**SUBJECT: FOSTER WHEELER ENVIRONMENTAL CORPORATION  
IDAHO SPENT FUEL (ISF) FACILITY  
RESPONSE TO NRC FOLLOW-UP CRITICALITY QUESTIONS  
DOCKET 72-25  
TAC NO. L23389**

**FWENC Response to NRC Follow-up Criticality Questions  
Docket 72-25  
TAC No. L23389**

**Figure 1 - Adjacent TRIGA Storage Tubes**

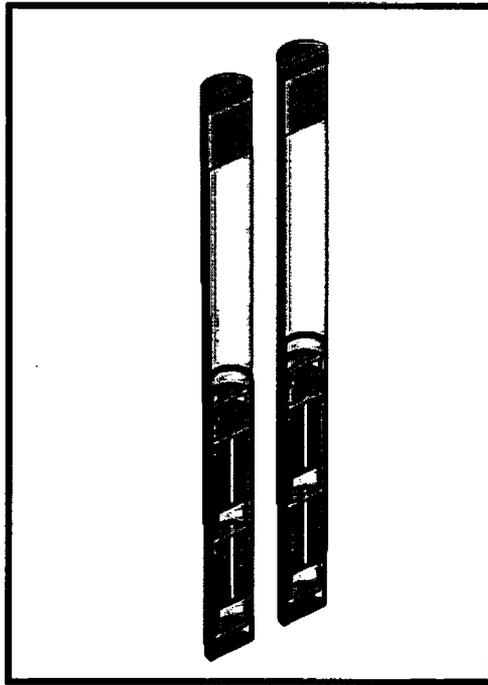
*FWENC response to NRC question 8-2, dated August 23, 2003, states there is neutronic isolation between fuel baskets in the vault, but criticality calculations do not appear to substantiate this statement. FWENC response to NRC Question 8-2, dated August 28, 2003, provides revised TRIGA criticality calculations for a higher fuel loading, which show the  $k_{eff}$  of Vault 2 loaded with TRIGA rods to be 0.8153, while Table 41 in Appendix 4A shows the  $k_{eff}$  of one Peach Bottom fuel element and two stacked TRIGA baskets to be 0.838. The  $k_{eff}$  of 0.023 does not appear to show neutronic isolation of the two baskets. Since the TRIGA baskets appear to be the limiting case, it is not clear why the  $k_{eff}$  for the mixed fuel type is larger than for Vault 2 full of TRIGA baskets. Either show neutronic isolation, or revise the criticality calculation as necessary to include a larger array size for the mixed fuel calculation.*

To further confirm that this case is bounding and that the vault storage tubes are neutronically isolated, FWENC has performed an additional series of calculations for each of the fuel types as well as mixed fuel vault configurations. A storage tube containing one canister of TRIGA fuel was modeled adjacent to another storage tube of identical configuration. Each tube was fully flooded (moderated) and reflected, similar to the case of the full TRIGA vault. The calculated  $k_{eff} + 2\sigma$  of this configuration of storage tubes was 0.8165. Figure 1 illustrates the geometry, minus the moderator and reflector (for clarity), that was evaluated. A 3x3, then a 5x5 array of TRIGA storage tubes was modeled and  $k_{eff}$  calculated for these fuel systems to determine if a significant variation from the adjacent storage tubes was noted. The calculated values of  $k_{eff} + 2\sigma$  were 0.8156 and 0.8165, respectively. Figures 2 and 3 illustrate the geometrical configuration of these two models. The similarity in  $k_{eff}$  for the various array sizes substantiates the FWENC position that the storage tubes are neutronically isolated from each other.

### Peach Bottom Bias Cases

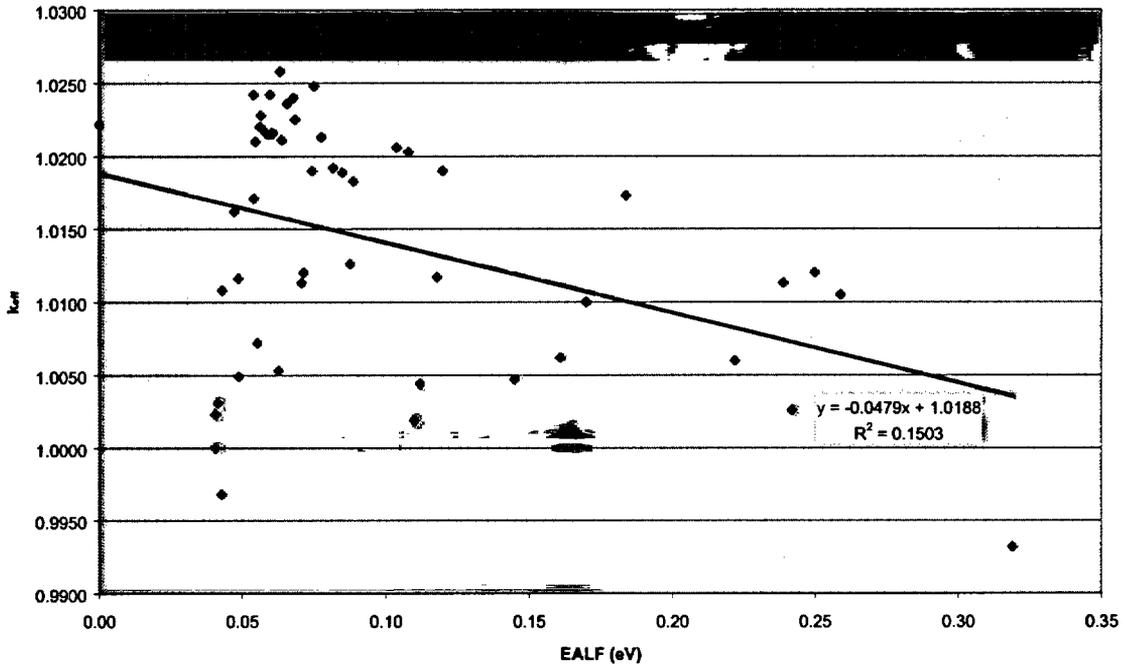
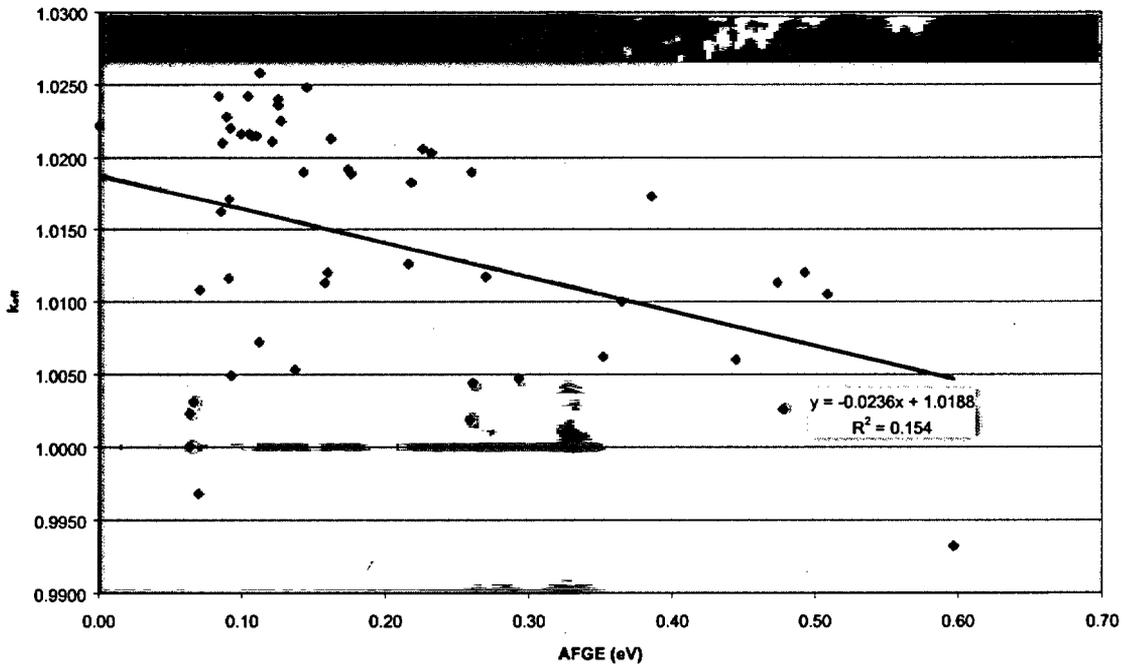
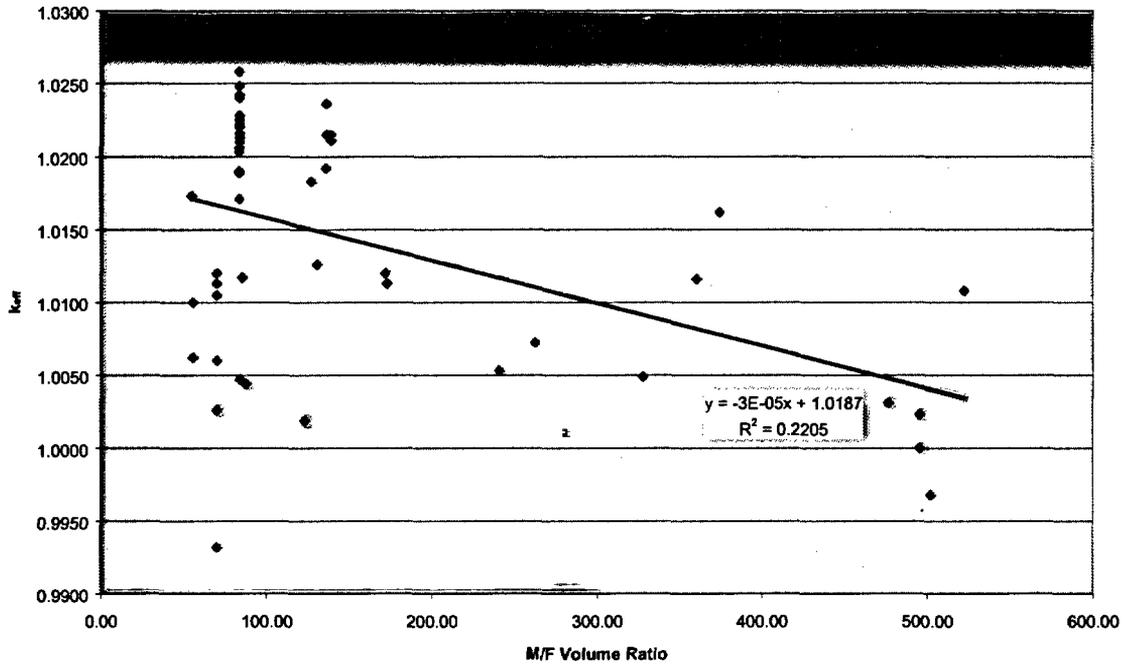
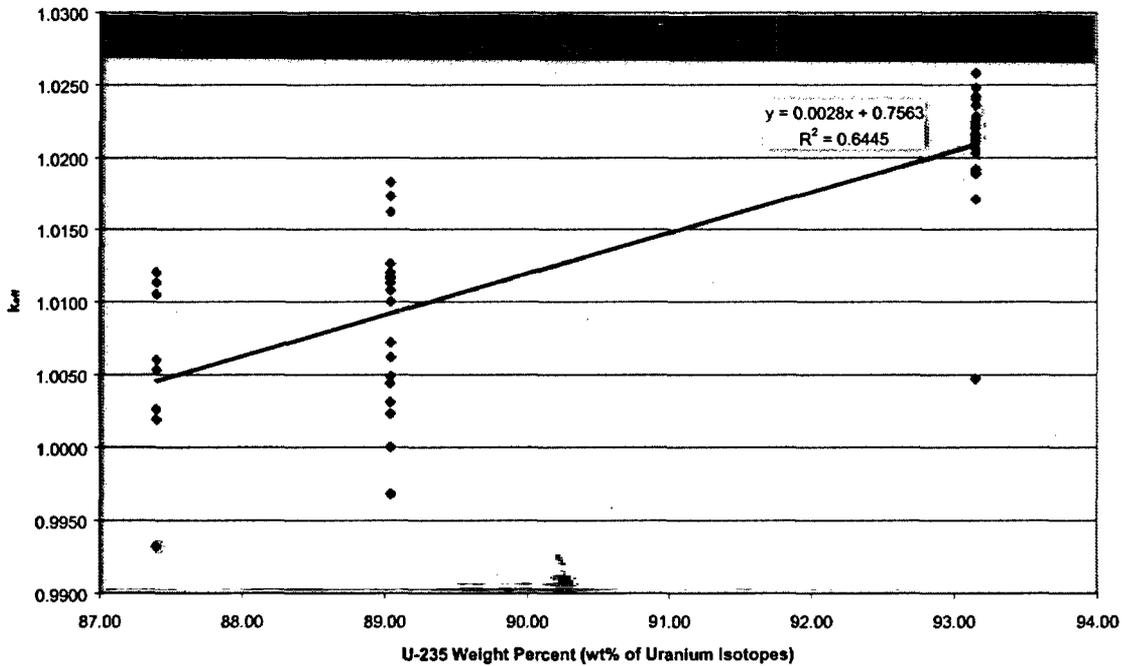
*The revised benchmarking analysis for MCNP 4C should have been evaluated for trends in the data, similar to the method for the MCNP Version 4B2 benchmarking. Statistically averaging all  $k_{eff}$ s to determine the bias is only appropriate when no trends exist in the data. Show that there are no trends in  $k_{eff}$  for the critical experiments, when compared against typical criticality safety variables, such as those shown in Table 4.2 of NUREG/CR-6361, "Criticality Benchmark Guide for Light-Water-Reactor Fuel in Transportation and Storage Packages" for both Peach Bottom and TRIGA fuel for MCNP Version 4C.*

The criticality benchmark experiments used for the bias evaluation of MCNP4C show similar results, i.e. there are no clear data trends discernable from the data. The following graphs plot the results of the benchmark cases as a function of several parameters for both Peach Bottom and TRIGA fuels. These parameters include:
